**ADDENDUM  
NO. 02**

**March 14, 2022**

**Warren Central High School Phase 3 Renovation and Addition  
9500 E. 16<sup>th</sup> Street  
Indianapolis, IN 46229**

This Addendum consists of Pages ADD 2-1 through ADD 2- 5, and attached CSO Architects Addendum No. 2 , dated March 13, 2023, consisting of 11 Pages, Specification Section 02 01 00 – Maintenance of Existing Conditions, and Addendum 2 Drawings: C101, C102, C401, C501, C502, C503, LD001, L101, L106, L201, L206, L301, L306, S201PRT, S202PRT, S501, S601, AD201N, A201M, A201N, A202N, A211G, A211M, A211N, A401, A404, A423, A431, A432, A600, A601, A602, A603, A611, A612, A701, A702, A703, A800, A801F, A801J, A801M, A801N, A801P, A801R, A801T, A802F, A802N, A802P, A802R, A802T, A900A, A900B, A901K, A902U, A903, A904, A905, A906, MD201F, MD201H, MD201J, MD201K, MD201L, MD202HJ, MD202N, M201F, M201J, M201K, M201L, M201N, M202HJ, M202N, M211F, M211H, M211J, M211K, M211L, M211N, M212HJ, M301, M303.

3.17 SHEET S601 – FRAMING SECTIONS

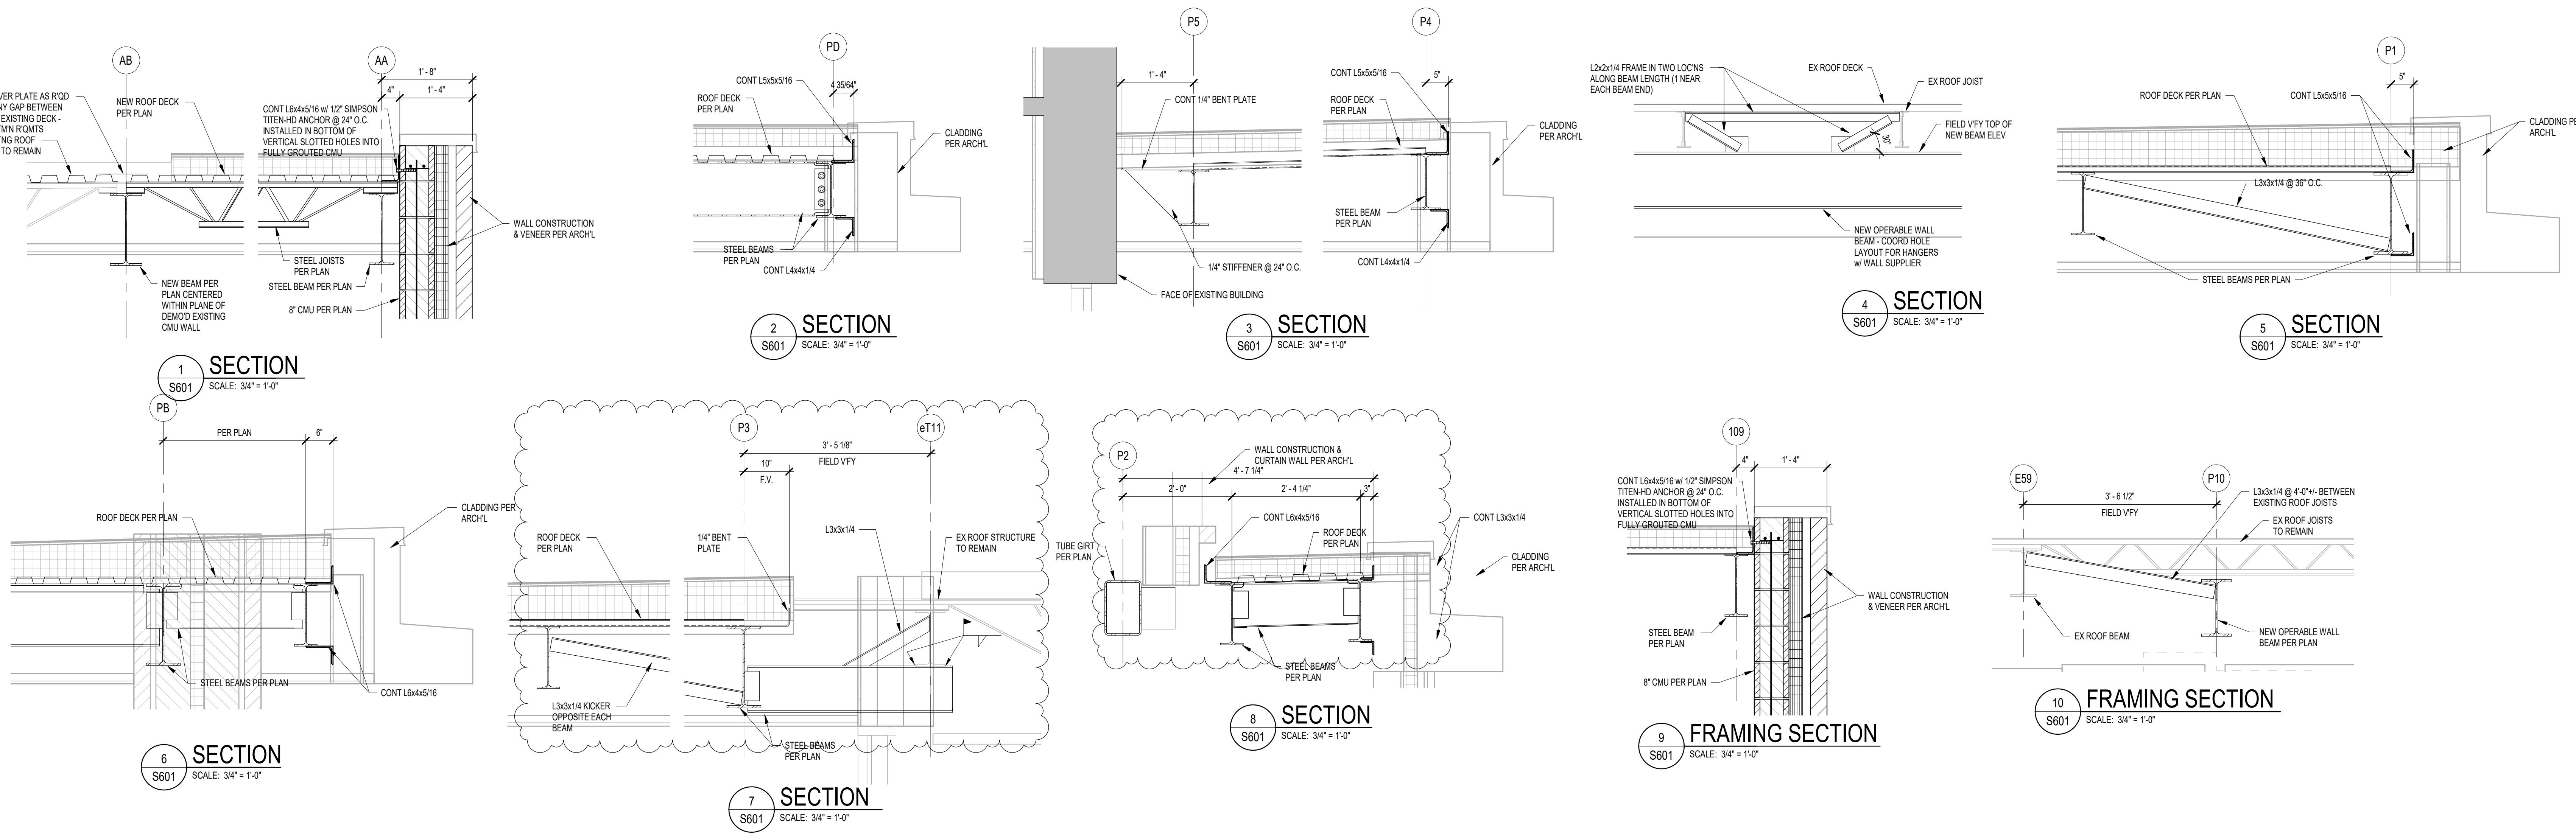
A. MODIFY sections 7 and 8 on attached, re-issued Sheet S601.

3.19 SHEET A201M – FIRST FLOOR PLAN – UNIT M

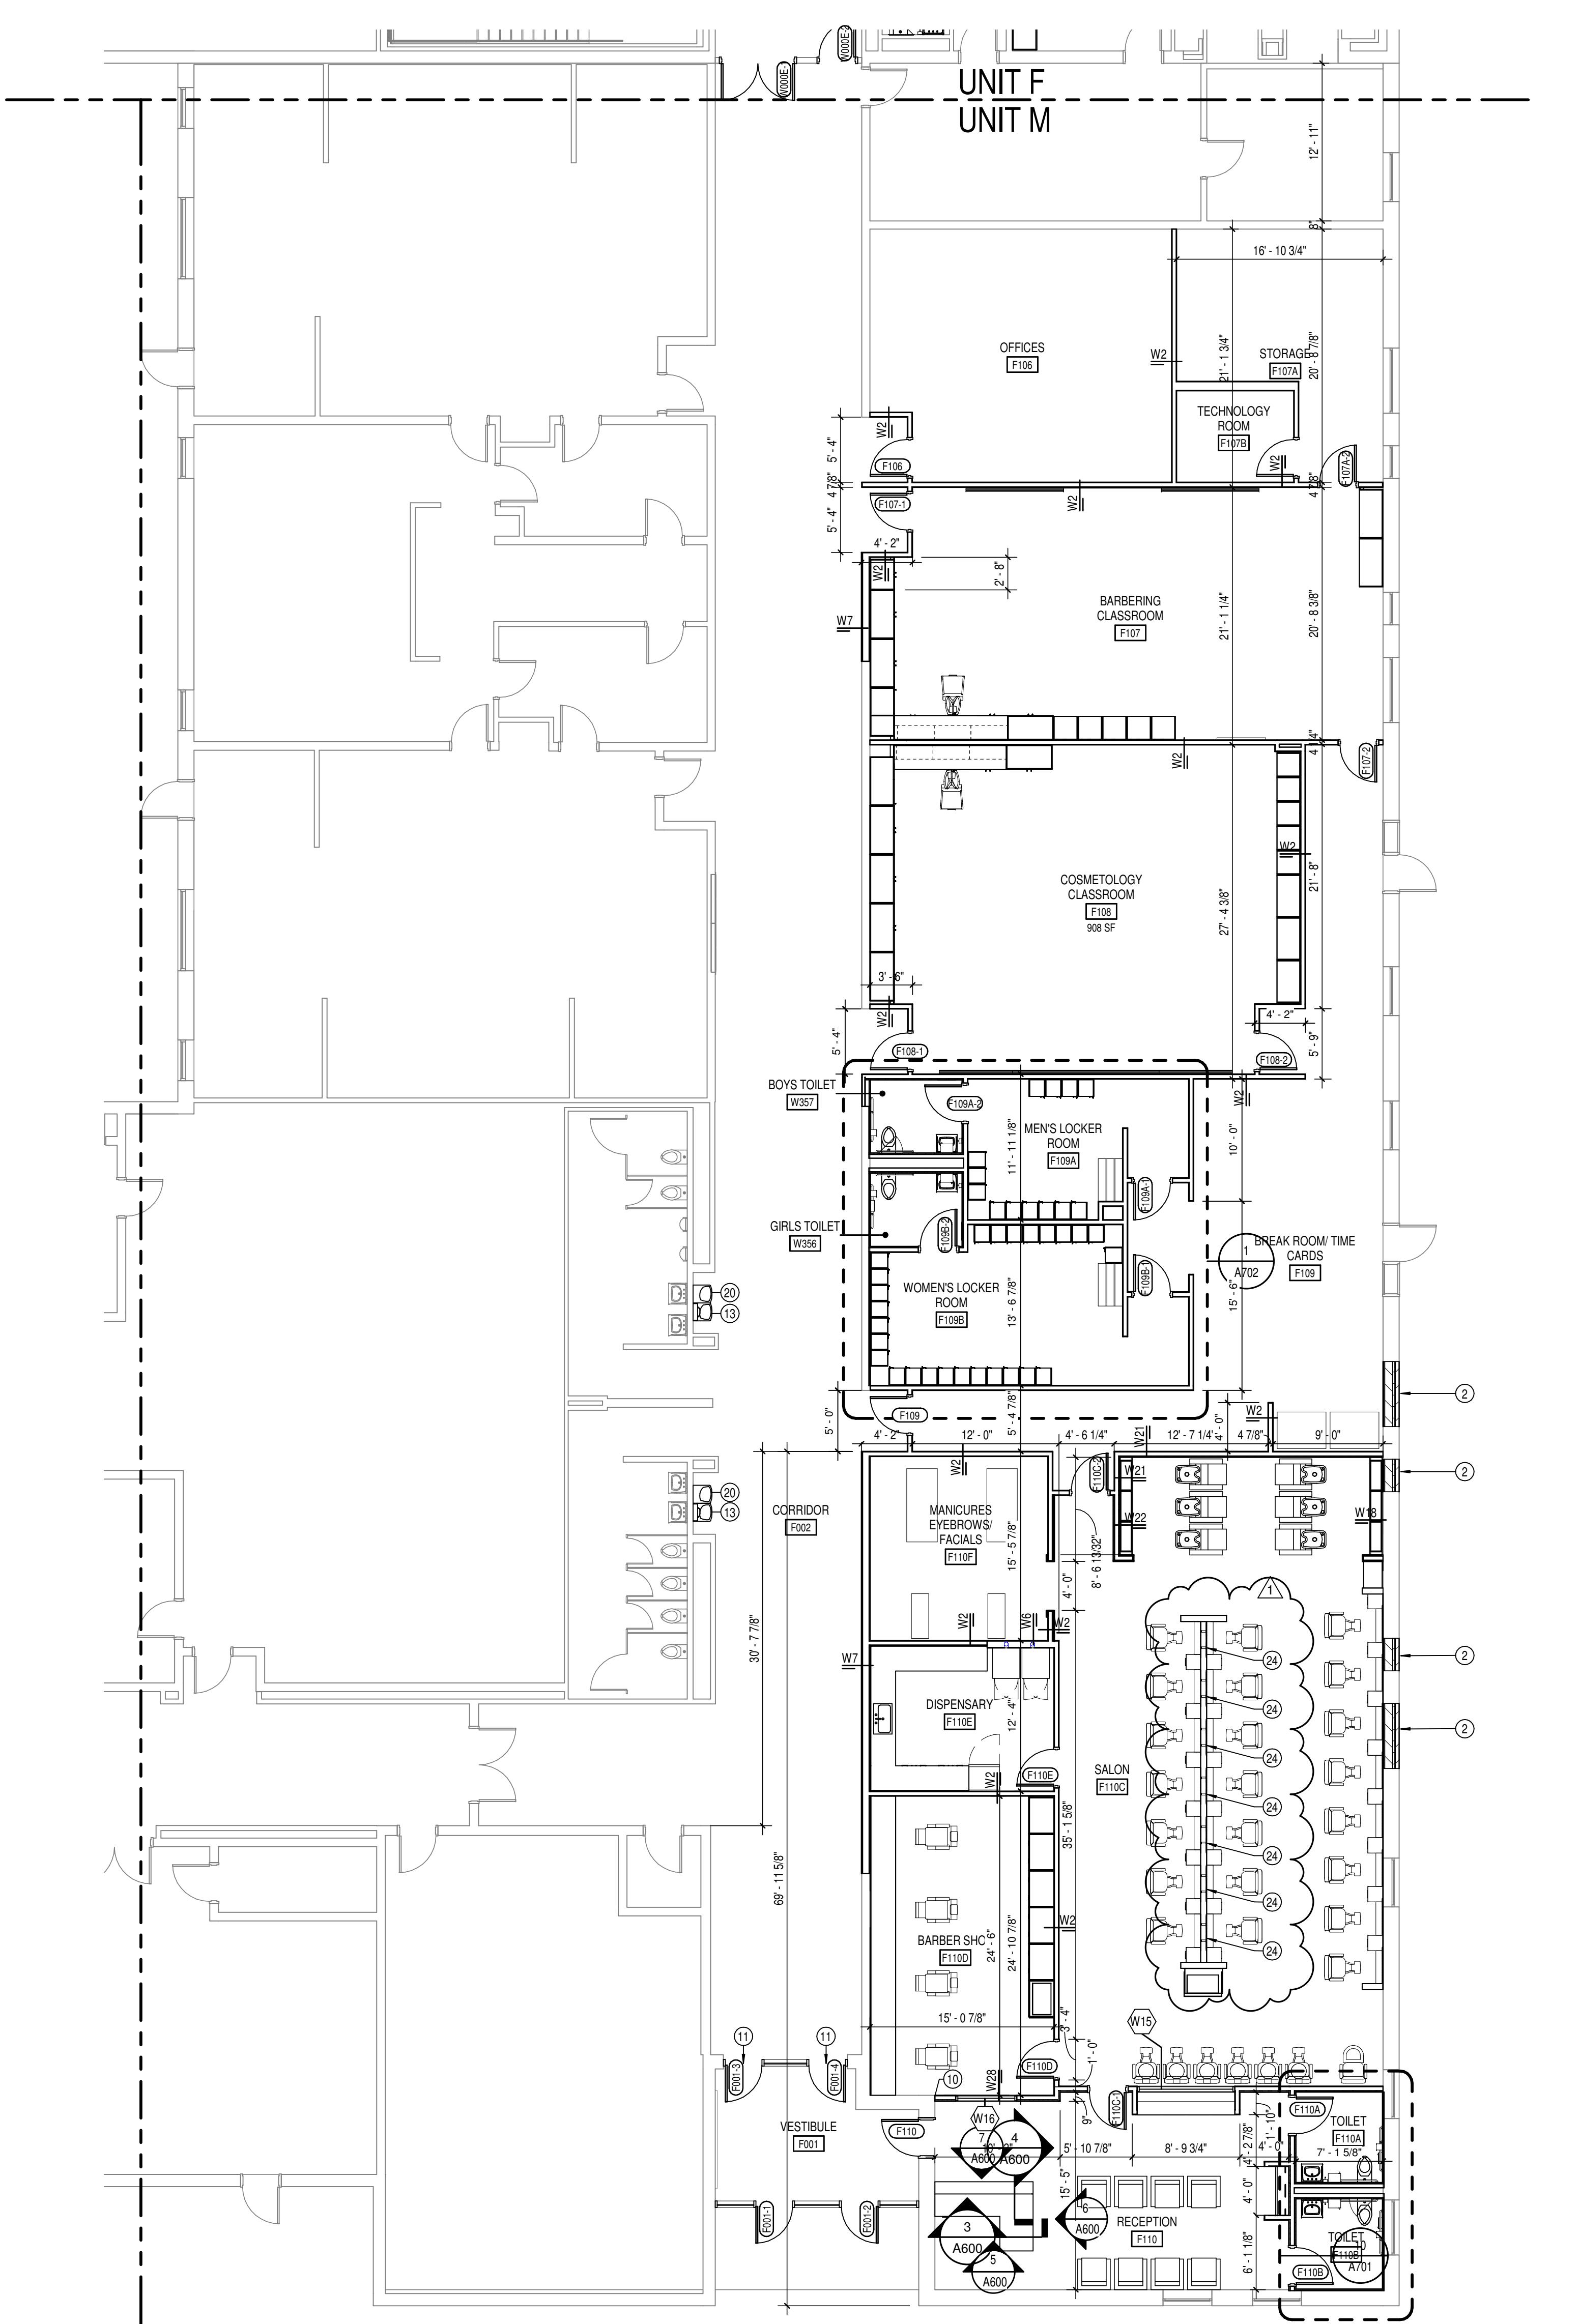
A. ADD aluminum tubes for mounting of mirrors as indicated on attached, re-issued Sheet A201M.

3.20 SHEET A201N – FIRST FLOOR PLAN – UNIT N

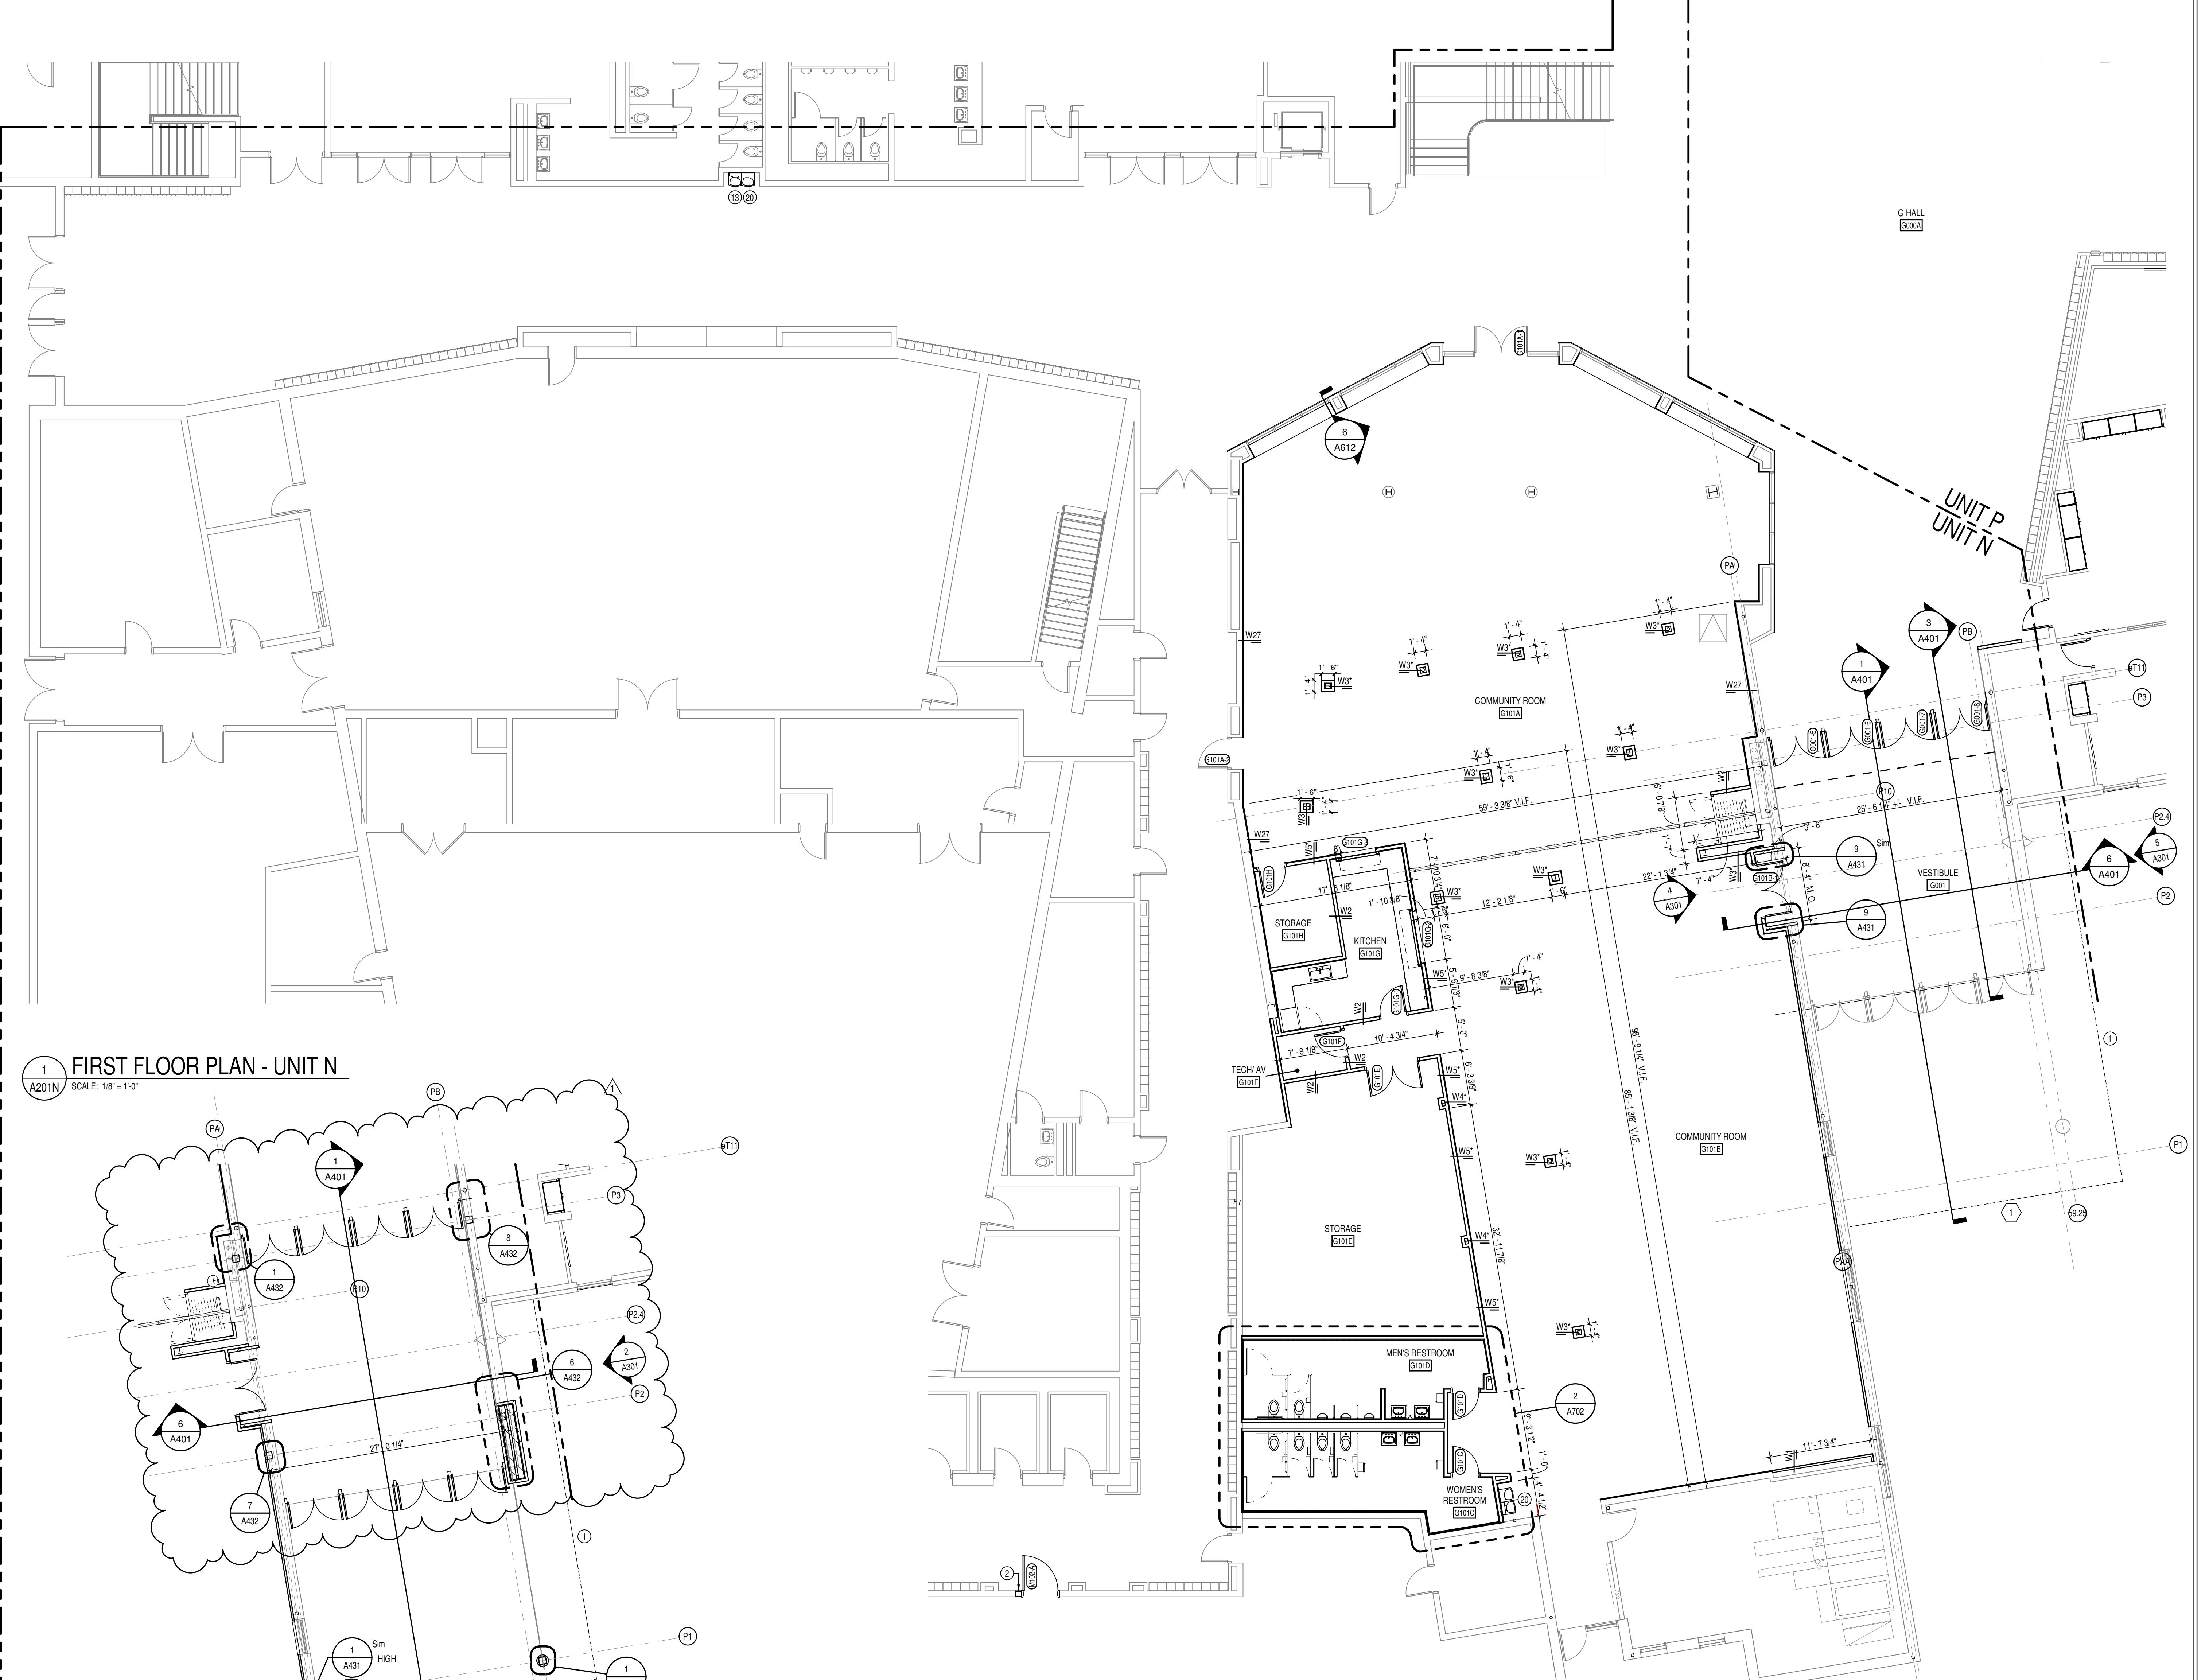
A. REVISE 2/A201N as indicated on attached, re-issued Sheet A201N
